WATERSTONE, Fil. No. 4-Site Plan

Technical Correction-Response to Comments

Re: Waterstone Filing No. 4
Site Plan Comments and Technical Corrections
Aurora, Colorado

C.05

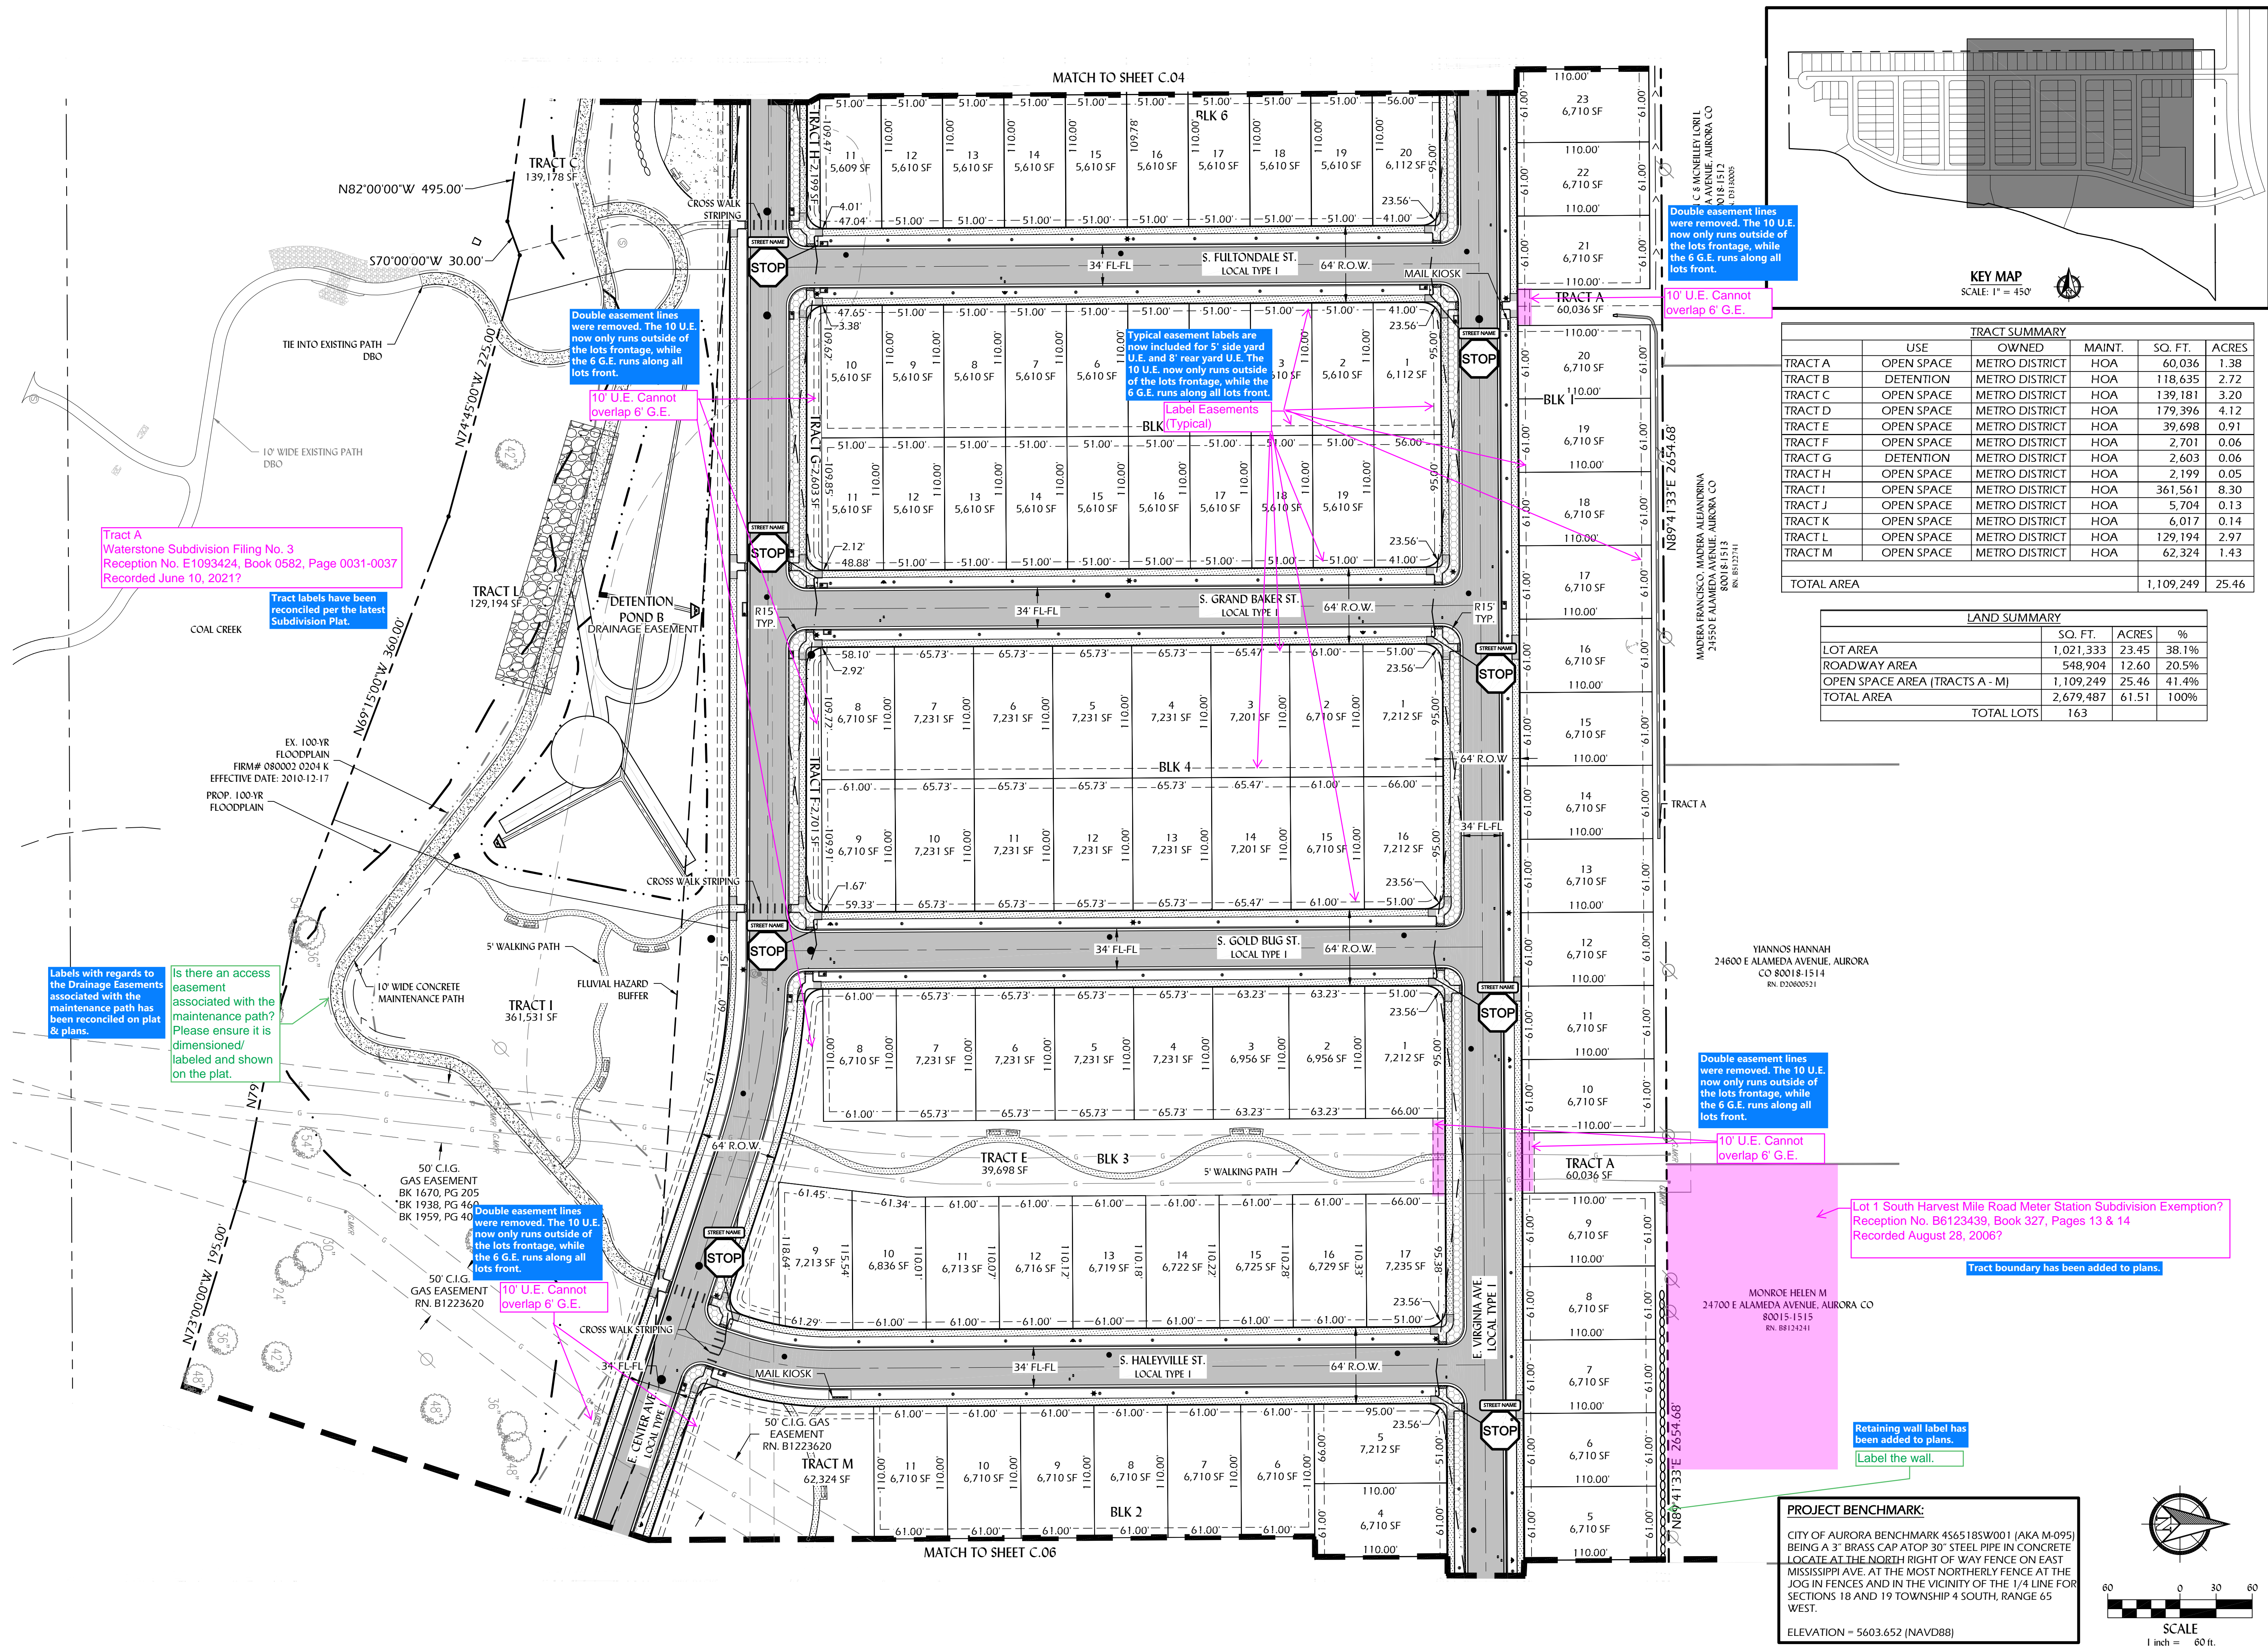
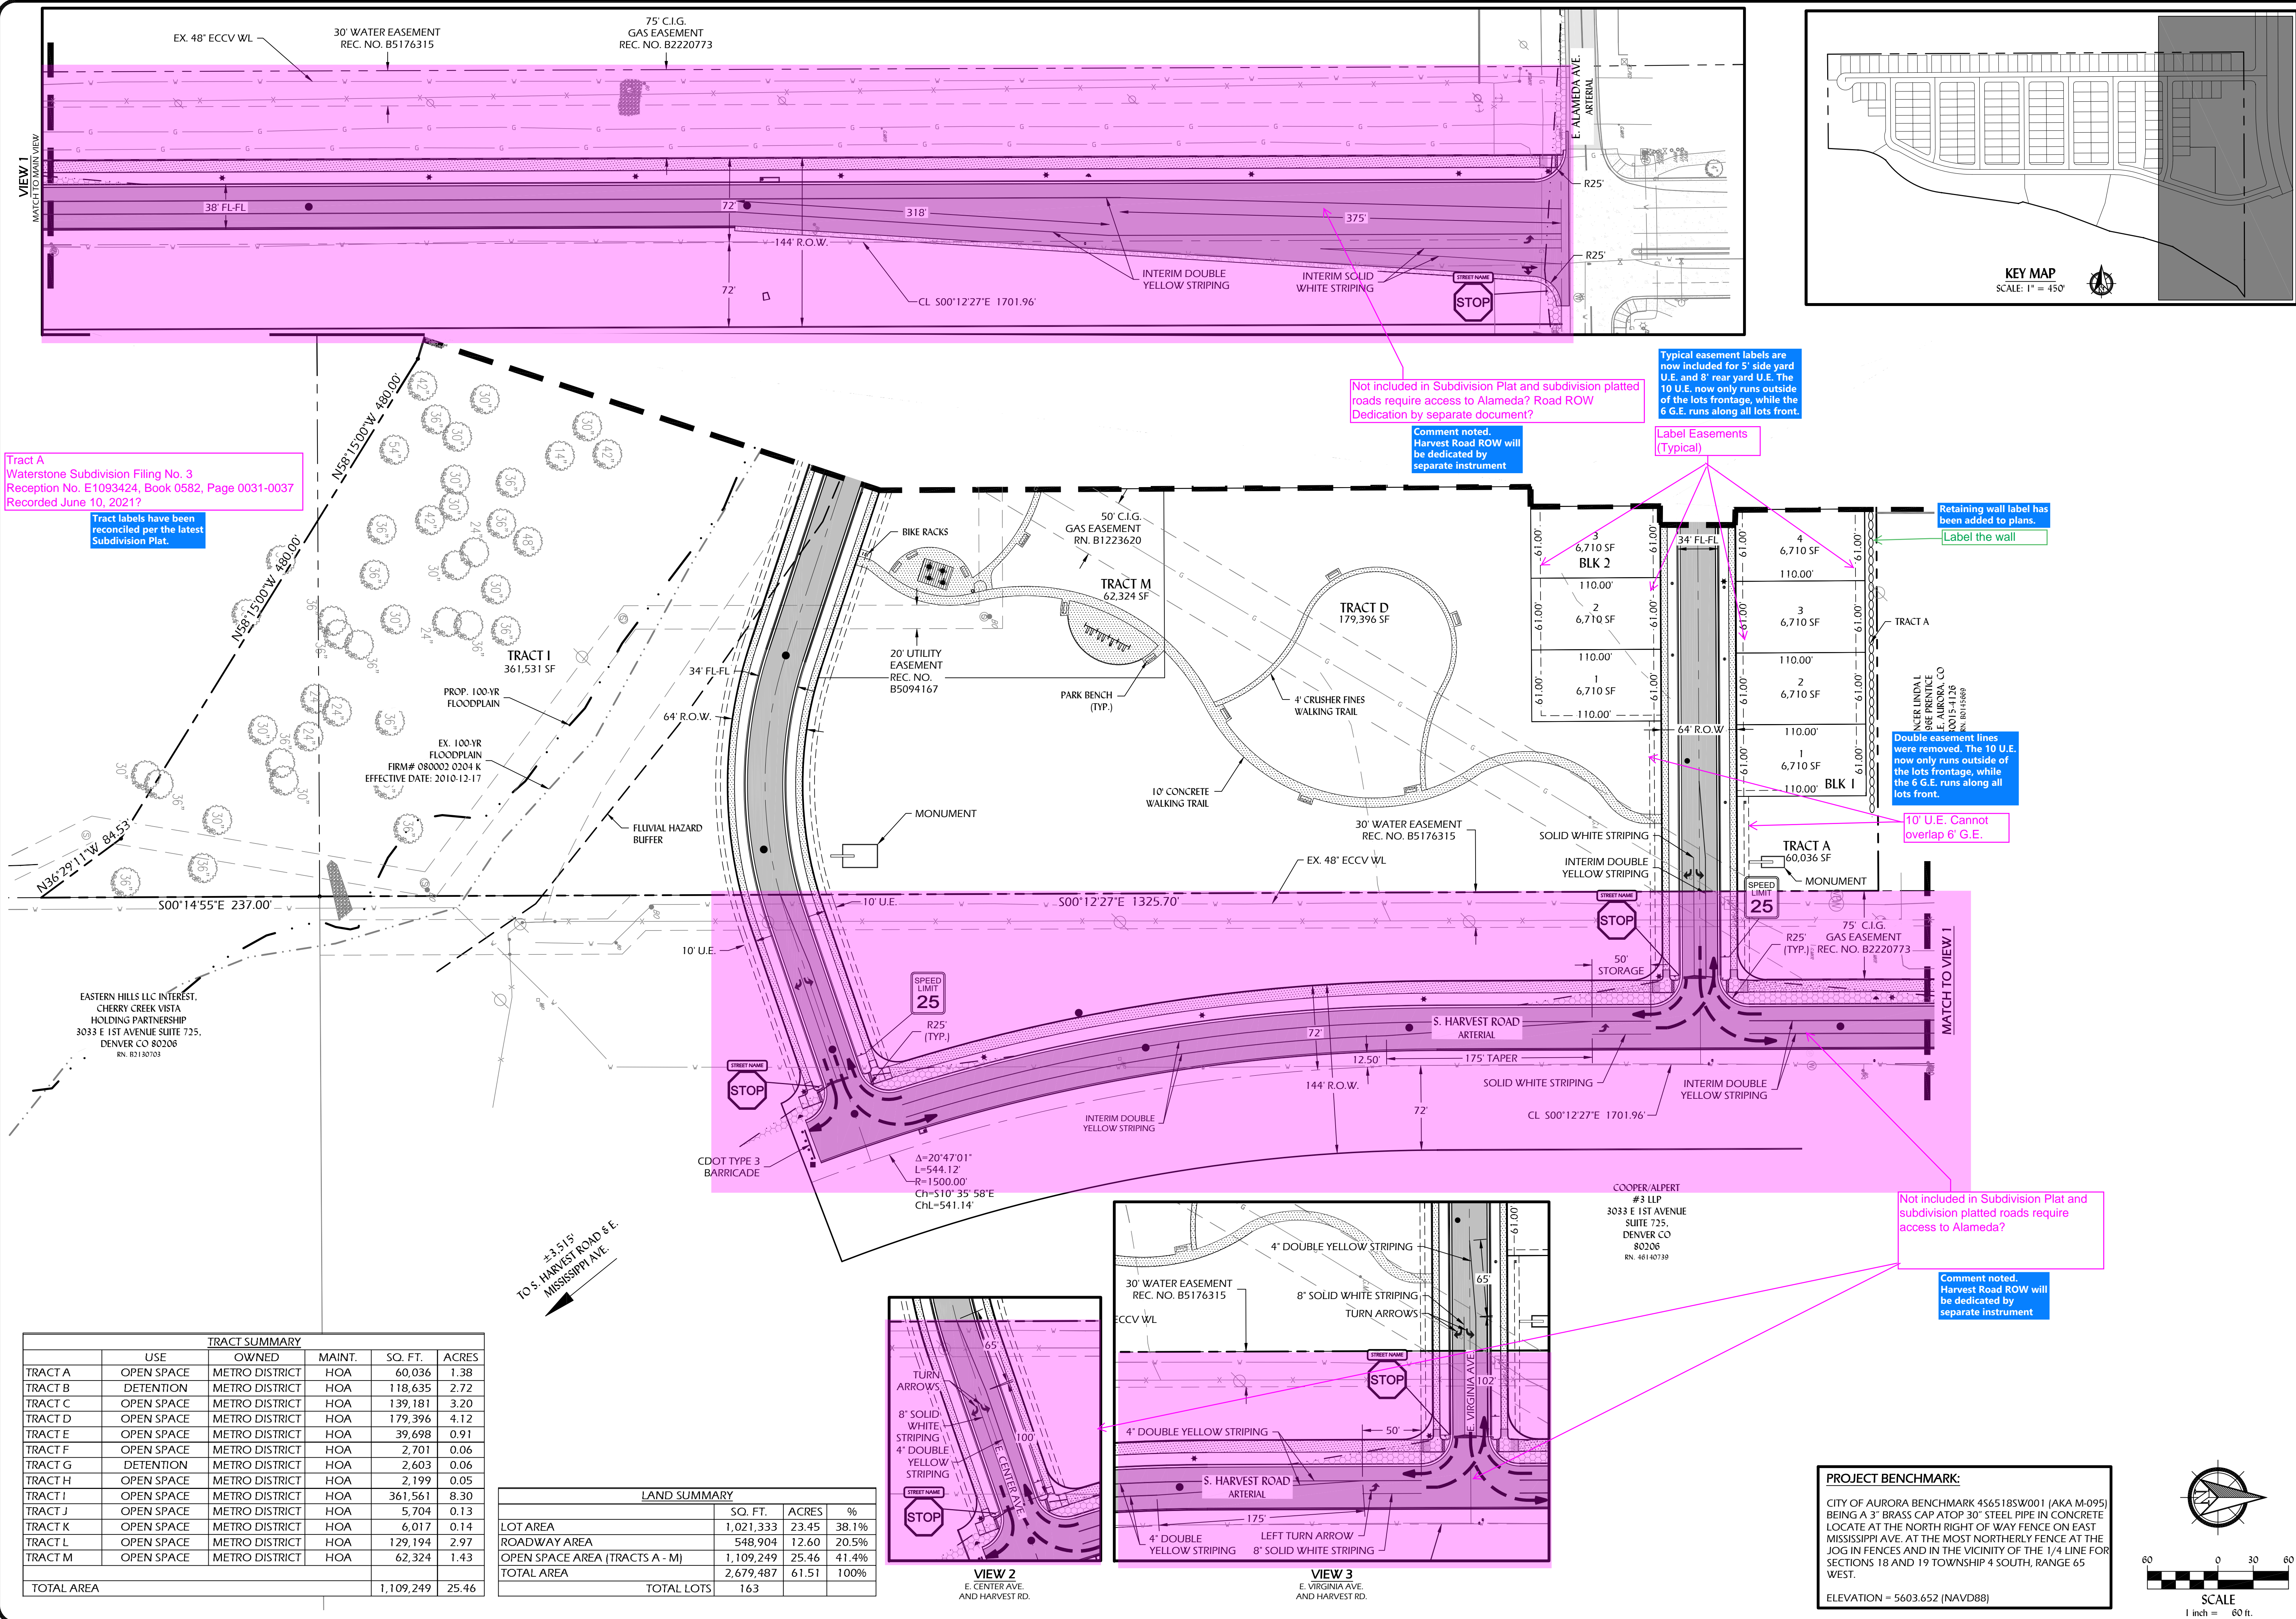
Add a note indicating if the storm sewer system is public or private and who will maintain it.

Note that identifies storm sewer ownership has been added.
